SAN FRANCISCO PLANNING DEPARTMENT

General Plan Referral

Date: May 31, 2018
Case No. Case No. 2015-006744GPR
**Demolition and Renovation of Margaret Hayward Playground's
Structures And Amenities**

CASE NO. 2015-006744GPR
DEMOLITION AND RENOVATION OF
MARGARET HAYWARD PLAYGROUND'S STRUCTURES AND AMENITIES

CDR Feedback from Phase I

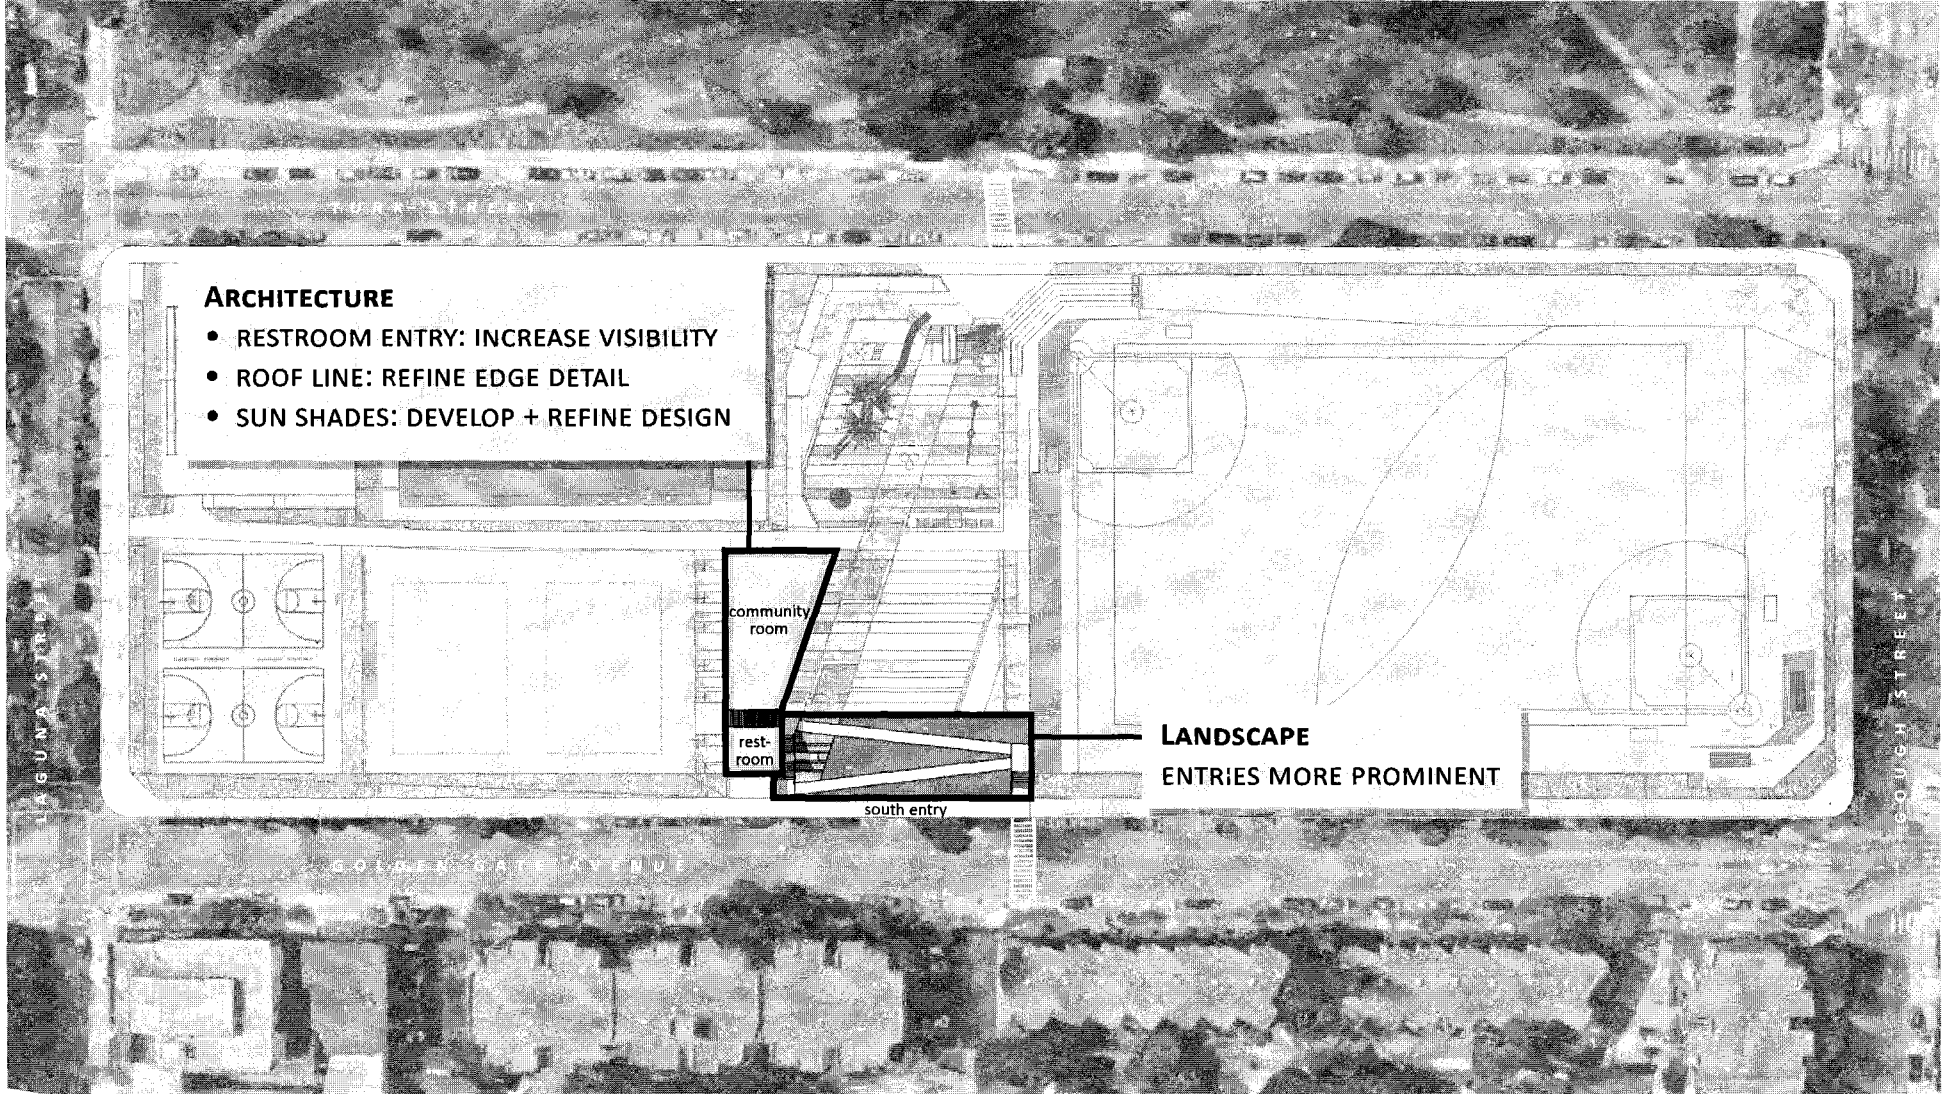
ARCHITECTURE

- RESTROOM ENTRY: INCREASE VISIBILITY
- ROOF LINE: REFINE EDGE DETAIL
- SUN SHADES: DEVELOP + REFINE DESIGN

LANDSCAPE ENTRIES MORE PROMINENT

FIXED/SEMI-FIXED PANELS
 ENTRANCE PANELS

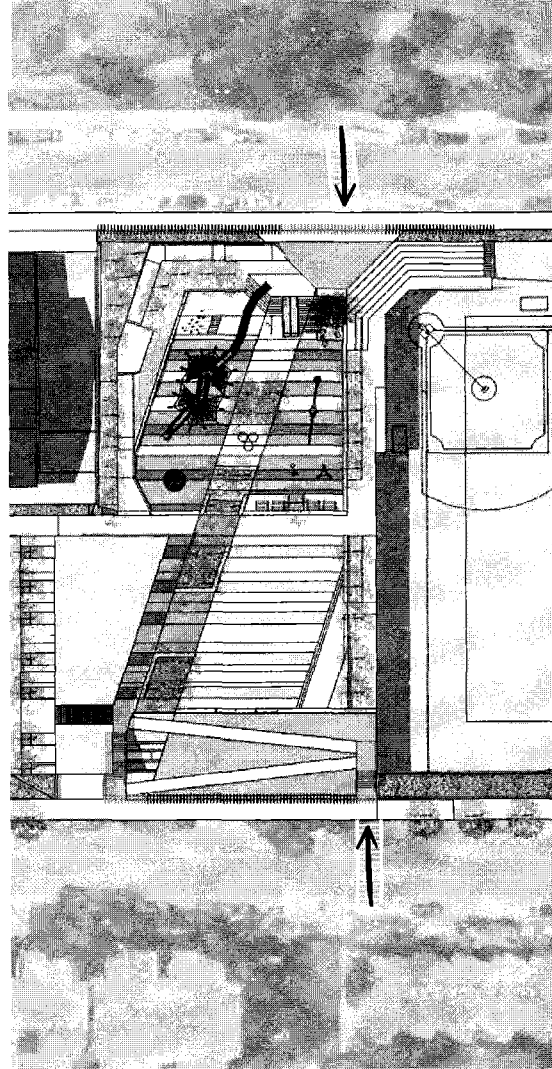
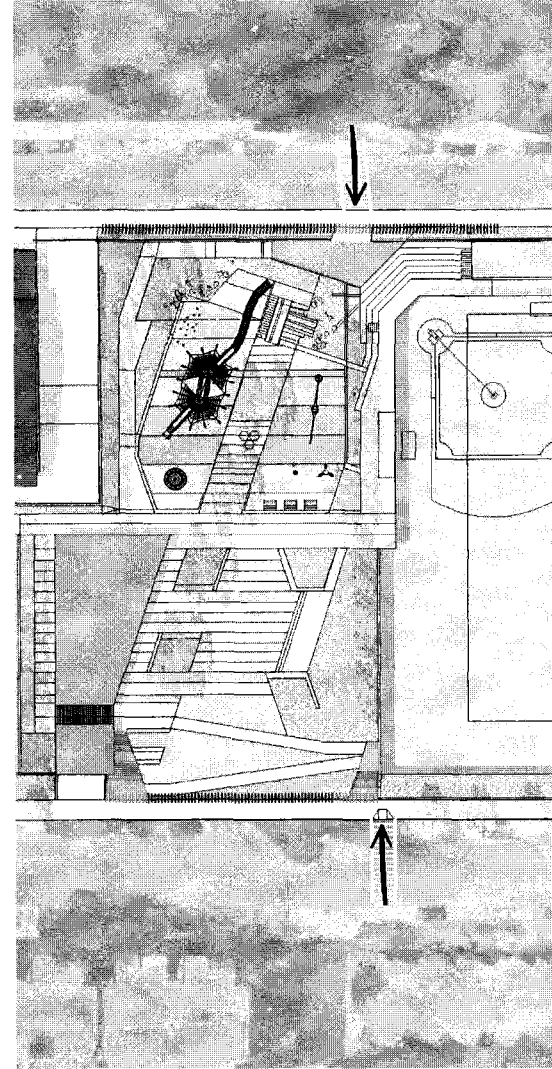
CDR PHASE 1

CDR PHASE 2
